Access Compliance Report

Public Rights-of-Way

Intersection ID: 2573	Main Street: CAMBELLTON_DR	Cross Street: PELORUS_LN	Location: NW
ADA ID: 9556E1C3747A	Ramp Type: PerpDiag	Initial Pass/Fail: Fail	Overall Compliance: No
Severity Score: 22.5			
Codes/Mitigation Info/Possible Solution		Field Measurements/Component Compliance

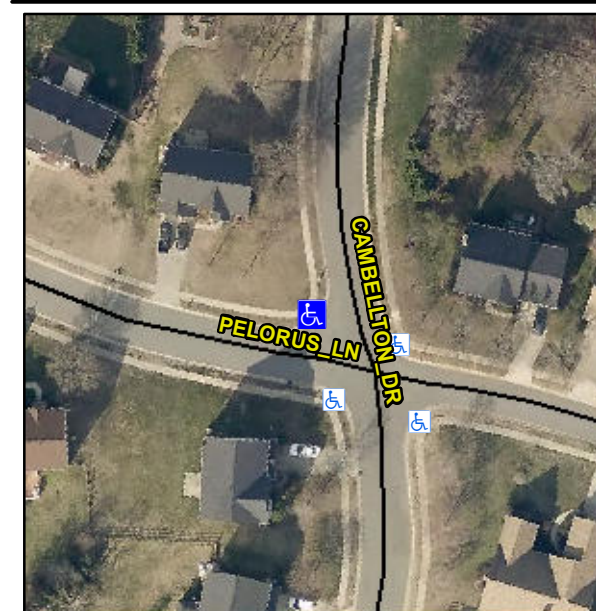
Not Found, R304.5.1, R304.2.2, R304.5.3

Compliance	Description	Data	Compliance	Description	Data
N/A	Ramp Length (in)	46.0	No	Ramp Slope (%)	8.4
No	Ramp Width (in)	41.0	No	Ramp XSlope (%)	3.3
N/A	Flare Type LT	N/A	N/A	Flare Type RT	N/A
N/A	Flare Slope LT (%)	N/A	N/A	Flare Slope RT (%)	N/A
N/A	Flare Traversable LT?	N/A	N/A	Flare Traversable RT?	N/A
N/A	Landing Length (in)	N/A	N/A	DWS Provided?	N/A
N/A	Landing Width (in)	N/A	N/A	DWS Contrast?	N/A
N/A	Landing Slope (%)	N/A	N/A	DWS Length (in)	N/A
N/A	Landing X Slope (%)	N/A	N/A	DWS Full Width?	N/A
N/A	Landing Curb? (Y/N)	N/A	N/A	DWS Offset (in)	N/A
N/A	Shared Landing?	N/A			
N/A	Gutter Ponding?	N/A	N/A	Gutter Slope (%)	N/A
N/A	Gutter Lip Ht (in)	N/A	N/A	Gutter X Slope (%)	N/A
N/A	Painted X Walk1?	No	N/A	Painted X Walk2?	No
	X Walk 1 Direction	To S		X Walk 2 Direction	To E
N/A	X Walk 1 Width (in)	N/A	N/A	X Walk 2 Width (in)	N/A
	X Walk 1 Slope (%)	3.9		X Walk 2 Slope (%)	2.4
	X Walk 1 X Slope (%)	1.5		X Walk 2 X Slope (%)	2.7

Remove & Replace Curb Ramp With Two New Directional Ramps or Equivalent.
